STAFF REPORT: 9/11/2024 MEETING

ADDRESS: 1815 SEMINOLE

APPLICATION NO: #HDC-2024-00473

SCOPE: ERECT ADDITION, ALTER CHURCH BUILDING

1815 Seminole, proposed site plan

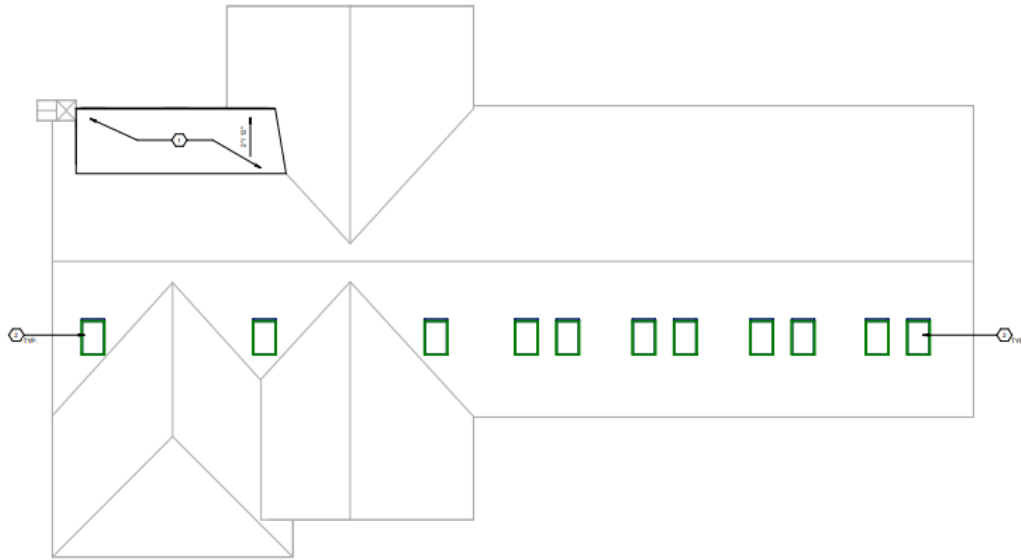
- The application is proposing to install new 6’-0” high aluminum picket fencing at the perimeter of the parcel. Although the above commentary states that the lawns should remain unenclosed, it is staff’s opinion that the placement of the fencing as

proposed in the current application is appropriate because five other properties within the 1800 block of Seminole, to include the adjacent parcel/the parcel to the south of 1815 Seminole, have similarly placed aluminum picket fencing. Perimeter fencing heights which exist at nearby properties are typically 6'-0" in height, although one lower/4'-0" perimeter fence is present within the 1800 block of Seminole.

- The application is proposing to remove Colorado Spruce trees because they have a fungal disease called Rhizophæra Needlecast per a letter supplied by a landscape designer. Staff’s Landscape Architect did confirm that the diseased trees should be removed because the fungus could spread to other trees on the property. The applicant has also noted that the sick/dying trees could fall on the building and/or neighboring properties. Staff therefore supports the proposed tree removal with the condition that three new replacement trees be planted at the property.

- Three new trees shall be plated within the property boundaries to replace the three diseased Colorado Spruce trees which are proposed for removal
- Staff shall be afforded the opportunity to review the final landscape and hardscape plan prior to the issuance of the project's permit

1815 Seminole, proposed roof plan

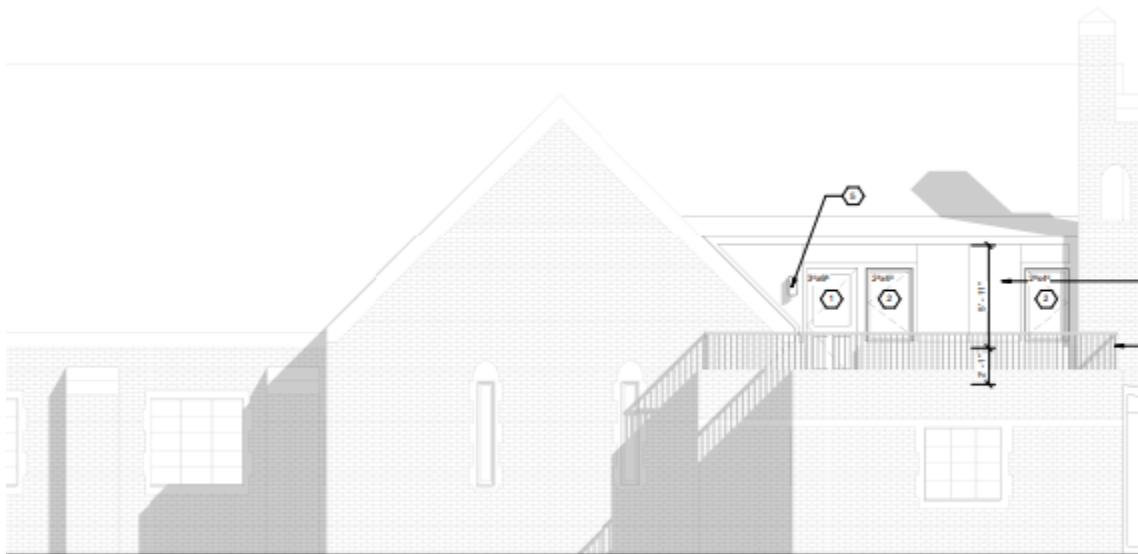
- Skylights to introduce additional interior daylighting may be acceptable, but only if they are minimally visible from the public right-of-way and do not extend past the ridgeline

- The application does propose to install new skylights at the south roof surface while retaining most of the building’s original windows. Per the submitted roof plan, the skylights will not extend past the roofline. The product cutsheet indicates that the skylights will be fixed and each will include a flat, clear glass vision panel. Although the skylights each measure 30”x60”, the applicant is seeking to install a row of 11 skylights, which will extend the full length of the south roof surface. When viewed from the public right-of-way facing west/northwest, the proposed grouping of 11 skylights will present as a highly-visible modern intrusion that is not compatible with the building’s historic character. Staff recommends that the number of skylights be reduced/the row of skylights be pushed back to the west so that the element will be less conspicuous from the street/sidewalk.

- The new railing proposed for installation at the roof of the flat-roof side wing shall not rise higher than 36"
- The number of skylights proposed for installation at the roof's east end shall be reduced so that the element will be less conspicuous from the street/sidewalk. The applicant shall provide a revised roof plan to staff for review and approval prior to the issuance of the project's permit.

Proposed rear/west elevation

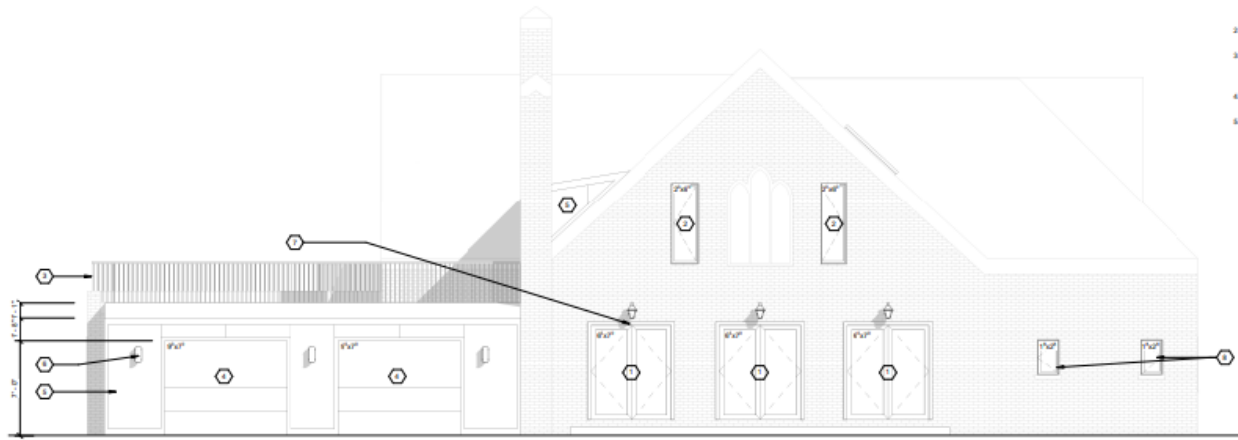
- The application does propose to utilize the less significant, flat-roof former administrative wing of the building for a new garage with the integration of a small, shed-roof addition to its rear/west wall, facing the alley. It is staff's opinion that the extension will be minimally visible from the public right of way and generally is compatible with the property's historic character due to its placement and scale. However, note that the addition of the extension will result in the removal of three steel casement windows (with non-historic multi-colored glass panes) at the wing's west wall (see the below photos). While the windows are historic age, they are located at the rear wall of the less significant administrative wing of the building. Also, the window openings at the wing's rear wall do not display the same decorative stone surrounds as those found at its more publicly visible front and side walls. Finally, note that the decorative stone course which appears above the window and door openings on the wing's front and side walls is not present at its rear wall. As this wing's rear wall does not reflect the overall design features which distinguish this building in regards to detailing and instead presents a more utilitarian appearance, and its demolition is necessary to accommodate the location of a garage extension, it is staff's opinion that the demolition the wall, to include the removal of the three casement windows is appropriate within the context of the proposed rehabilitation.

- The new doors and windows proposed for location at the rear/west wall and south wall/ the lower hipped-roof southwest wing of the building will result in the removal of three original steel casement windows with non-historic, multi-colored glass panes (see the below). As is the case with the windows at the flat-roof wing, these windows lack the decorative leaded glass detailing and stone surrounds of the more prominent, significant windows as they are located in a wing that are off the sanctuary, to the rear of the church. It is staff’s opinion that their replacement is appropriate because windows do not reflect the overall design features which distinguish this building in regard to detailing and instead present a more utilitarian appearance than the character-defining windows which are present the building’s sanctuary walls.

- The application does not specify the finish of the new composite siding which will clad the garage extension and new rooftop dormer addition. Composite siding with a faux woodgrain finish is not appropriate for historic districts because they do not adequately approximate the look of a historic painted wood clapboard siding. Staff therefore recommends that the siding display a smooth finish.
- The new skylights will be highly visible from the public right-of-way as they will extend nearly the full length of the south roof's surface. Staff recommends therefore recommends that the number of skylights proposed for installation at the roof's east end be reduced so that the element will be less conspicuous from the street/sidewalk.

- The siding which shall be installed at the garage extension and new dormer shall display a smooth finish/shall not have a faux wood grain finish. The permit drawings shall be revised to note that the garage siding will be smooth.
